# PLANNING AND ZONING CASE CHECKLIST

P&Z CASE # SP2019-043 P&Z DATE 12/30/19 CC DATE \_\_\_\_\_ APPROVED/DENIED \_\_\_\_\_  
ARCHITECTURAL REVIEW BOARD DATE \_\_\_\_\_ HPAB DATE \_\_\_\_\_ PARK BOARD DATE \_\_\_\_\_

Date: 2019-12-13 Job Number: 2019-001  
 Project Name: Ranch Trail Office Park  
 Project Submittal: Amended Site Plan – SP2019-043  
 To: Korey Brooks  
Senior Planner  
City of Rockwall  
385 S. Goliad Street, 75087  
972.772.6434

Re: Ranch Trail Office Park– Amended Site Plan - SP2019-043

SHEET  
**SP-1**

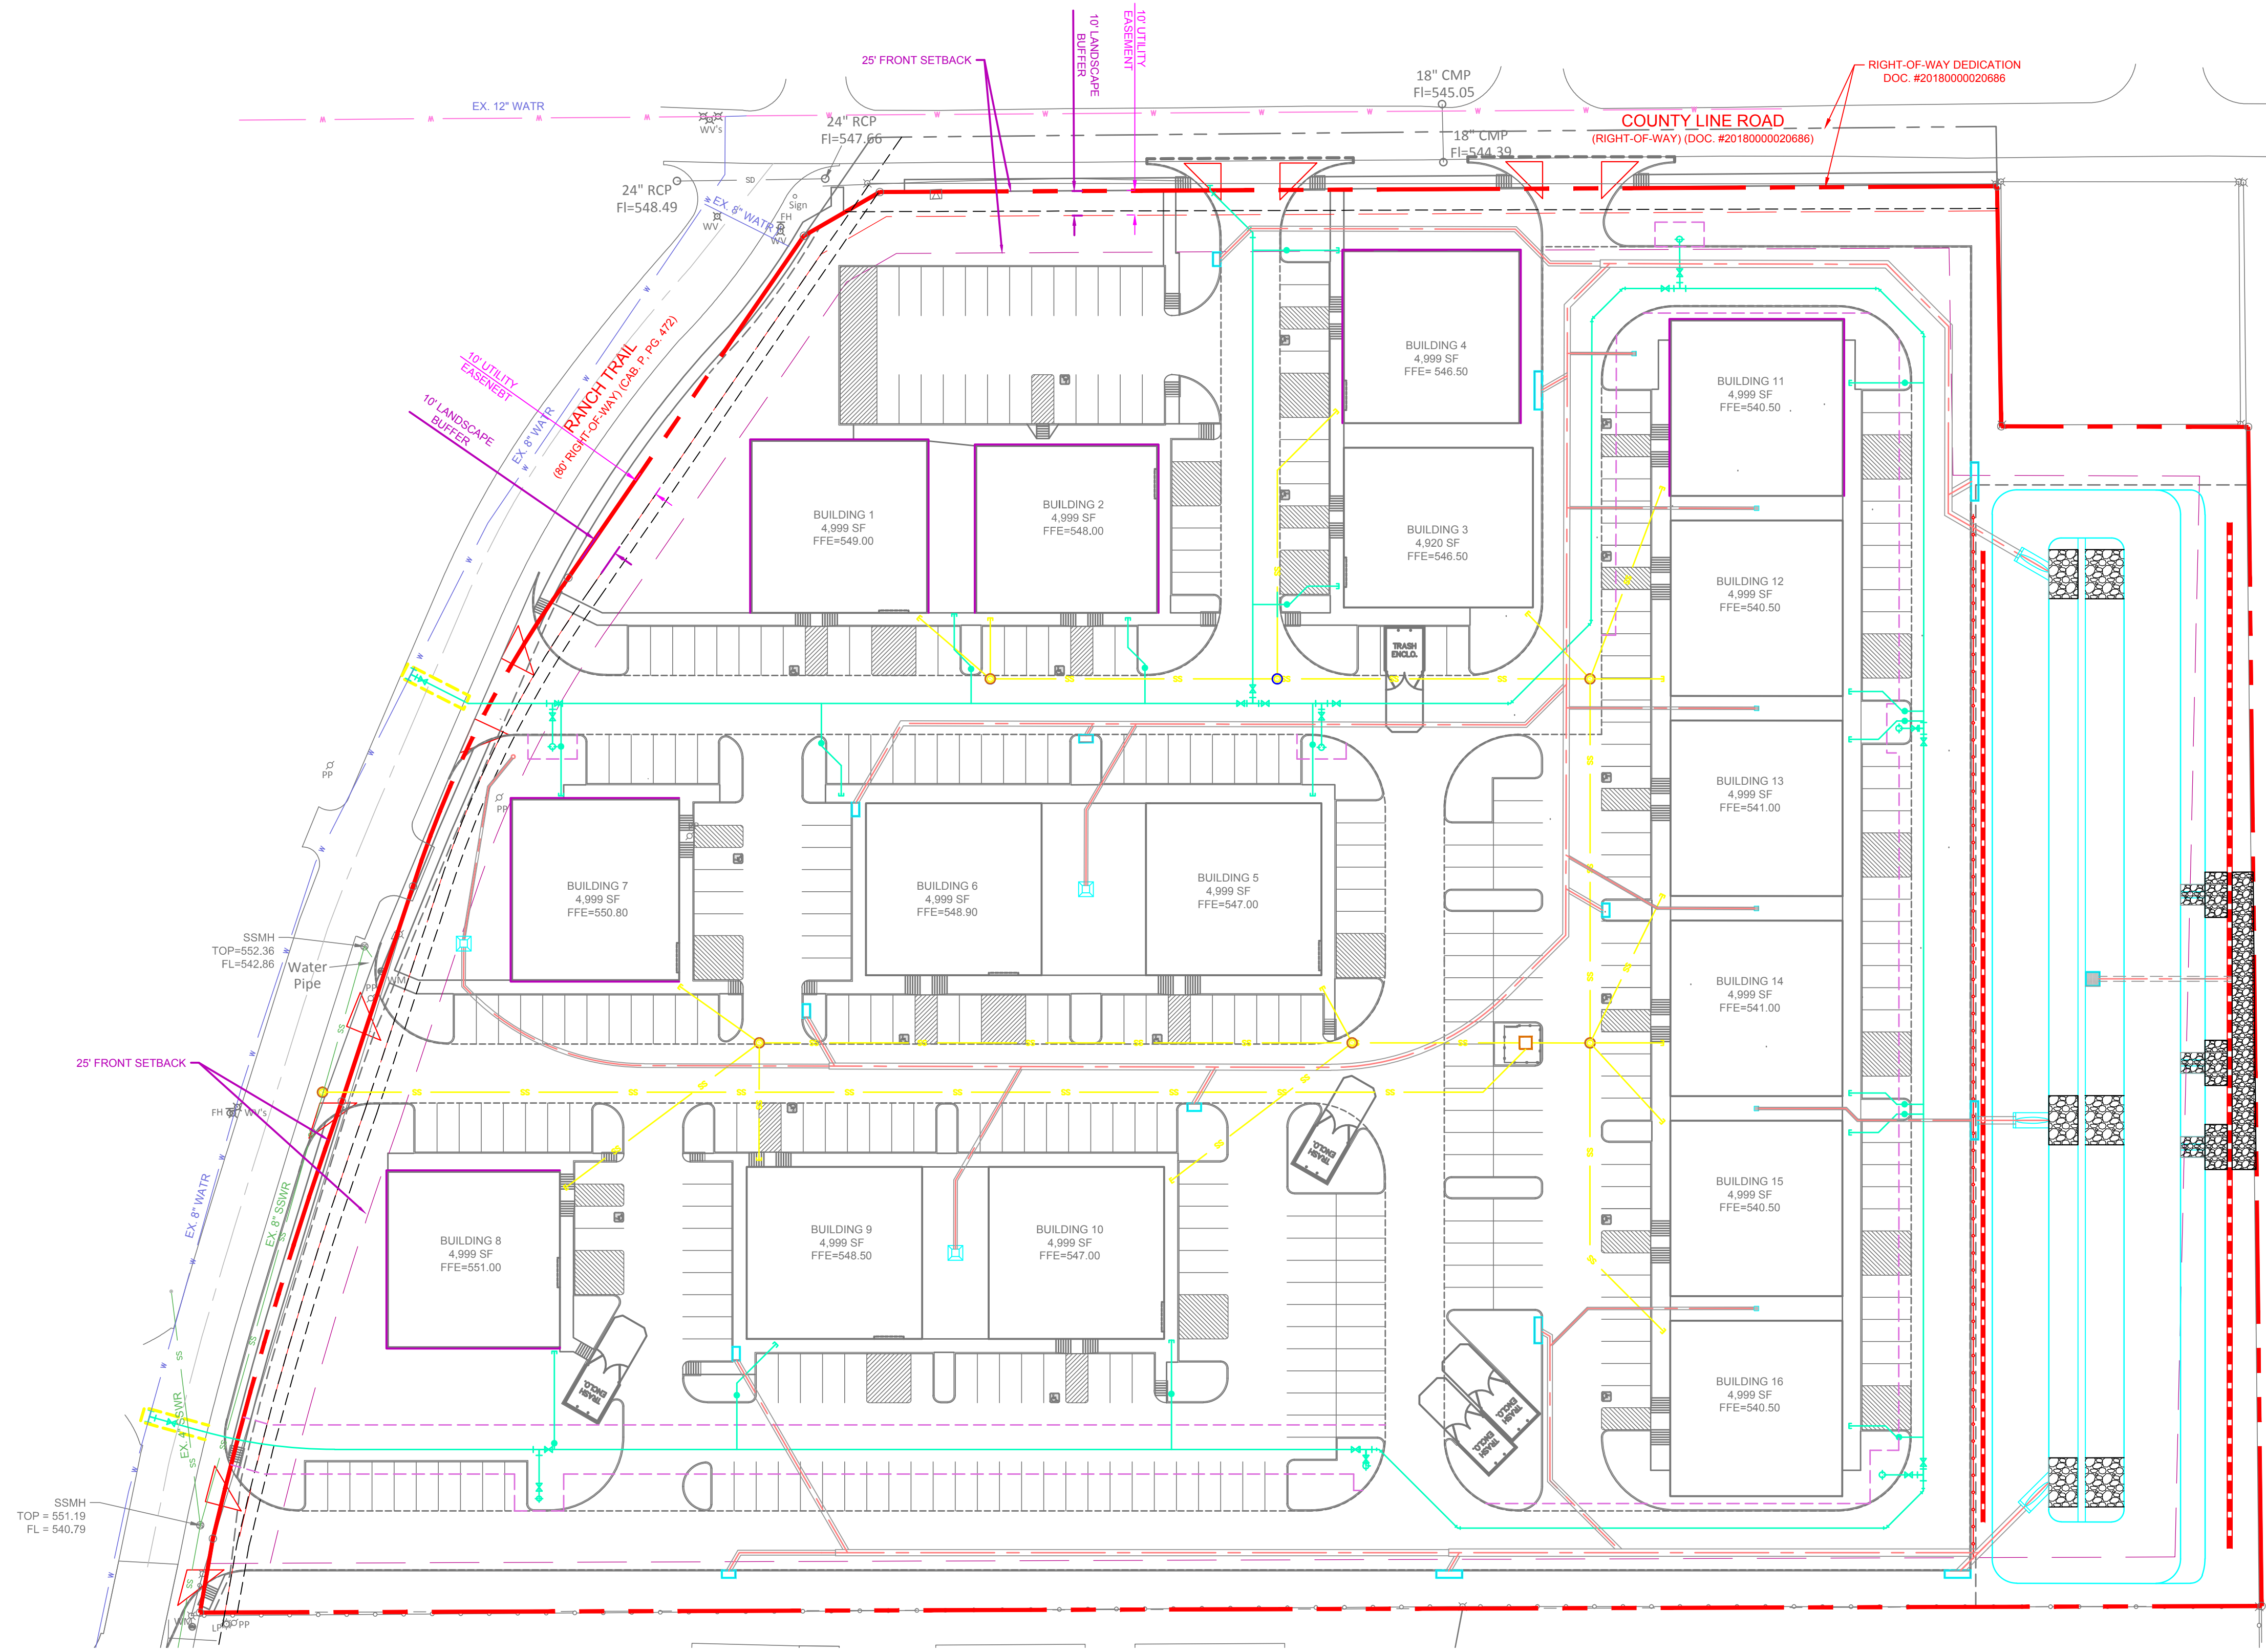
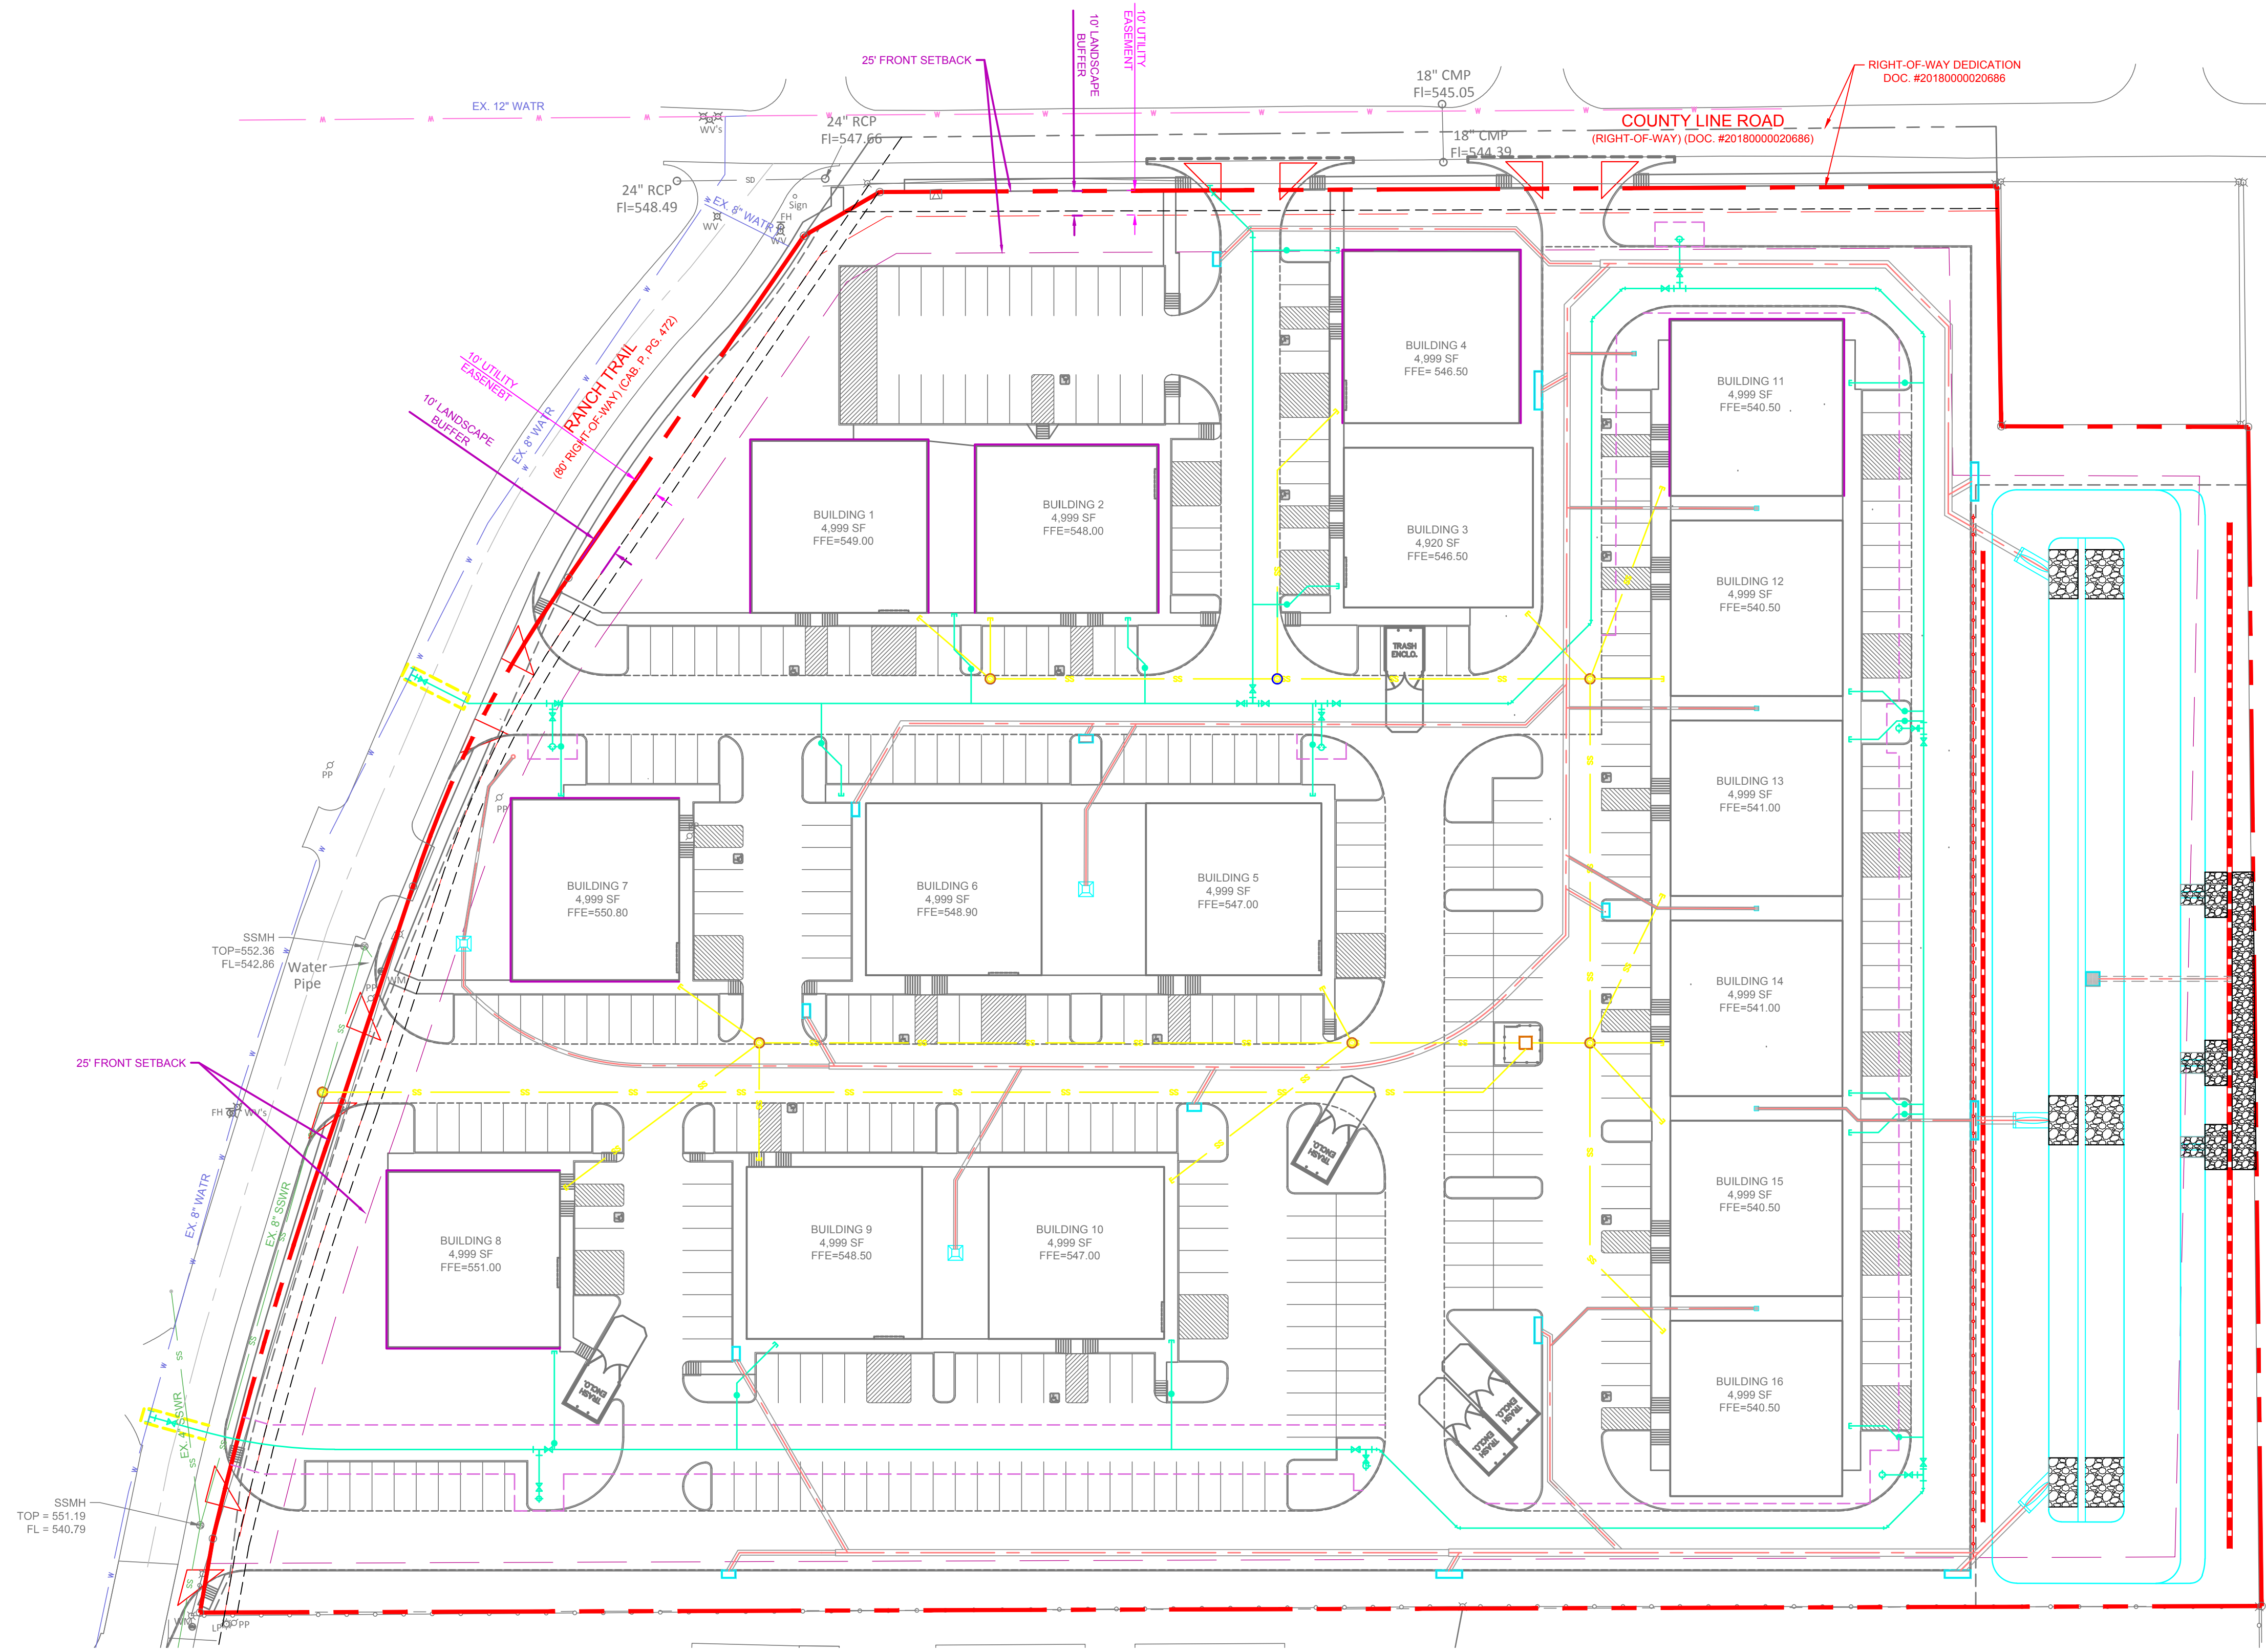
1. Site Plan. Please check driveway spacing with the Engineering Department and the “Future Driveway Connection”.  
***THIS COMMENT WAS ALREADY DISCUSSED & APPROVED BY THE CITY.***

2. Site Plan. Please note that at 5,000 SF, the buildings will need to have a sprinkler system. The Fire Department may already require a sprinkler due to the type of use.

4. Site Plan. Please show any rollup doors on the building (i.e. provide a notch or something that indicates where the doors are located).  
***ROLLUP DOORS INDICATION HAVE BEEN SHOWN WITH THE LOADING AREA STRIPING IN FRONT OF IT.***

5. Please note that roll-up door should not be visible from the street.  
***NO ROLLUP DOORS PROVIDED FACING MAIN STREETS.***
6. Site Plan. Please show easements

***EASEMENTS HAVE BEEN SHOWN ACCORDINGLY.***
7. Site Plan. In order to clean-up the plan, please remove the ADA symbols and callouts. Also, for other items, try to limit callouts and maybe utilize hatching/shading and provide information in a legend.

8. Site Plan. Please provide SF of office and SF of warehouse for each building.  
***AT THIS TIME, THE BUILDINGS ARE SHELL BUILDINGS. EACH TENANT WILL FINISH OUT THE SPACE AS THEY NEED. THE SITE PLAN CURRENTLY ACCOUNTS FOR THE SITE TO PARK AT 100% OFFICE SO THAT IT CAN HELP ACCOMMODATE THE NEEDED SPACE.***

9. Site Plan. Perhaps, number the buildings (for site planning purposing only) so that they are easier to refer to.  
***BUILDINGS ARE NUMBERED ON THE SITE PLAN.***

10. Site Plan. Please utilize a combination of lineweights, especially adjacent to Ranch Trail. Things seem to get lost and it's difficult to see centerline of Ranch Trail vs dimensions, etc.

***THE LINEWEIGHTS USED ARE THE SAME AS THE PREVIOUSLY APPROVED SITE PLAN.***
11. Site Plan. Please note that the dumpster cannot directly face the street. Perhaps they can be angled?

***ALL DUMPSTERS MATCHED THE SAME LOCATION AS THE PREVIOUSLY APPROVED DUMPSTERS.***
12. Site Plan. Is the footprint of each building going to be perfectly square, rectangle, etc? If not, please show the building footprint as it would actually appear.

***BUILDING FOOTPRINTS SHOWN ARE MATCHING WITH THE ELEVATIONS.***
13. Site Plan. Add a note that the dumpster enclosure shall have an opaque, self-latching gate. Also, check the minimum dimensions of the enclosure to ensure compliance—they seem to be slightly undersized. Please see standards below.

***DIMENSIONS AND NOTES FOR THE GATES HAVE BEEN ADDED ON THE DUMPSTER.***
14. Site Plan. The substitution of symbols in a legend rather than call outs would be helpful.

***NOTED. THANK YOU.***
15. Site Plan. The parking spaces need to be behind the front façade of the buildings. There are two or three parking spaces located at the drive aisle off county line road that will need to be moved.

***THIS COMMENT HAS ALREADY BEEN DISCUSSED AND ACCEPTED BY THE CITY.***
16. Site Plan. The parking space closest to the dumpster enclosure at the east property line may have to be eliminated due to lack of backing out space.

***NOTED. THANK YOU.***
3. Site Plan. Please note, there will need to be heavy landscape screening at the property lines.  
***LANDSCAPE SCREENING HAVE BEEN PROVIDED ALONG PROPERTY LINES.***

***SITE PLAN HAS BEEN CLEANED UP AS POSSIBLE.***

***THIS COMMENT HAS ALREADY BEEN DISCUSSED AND ACCEPTED BY THE CITY.***
17. Site Plan. Please note our updated screening requirements for residential adjacency.
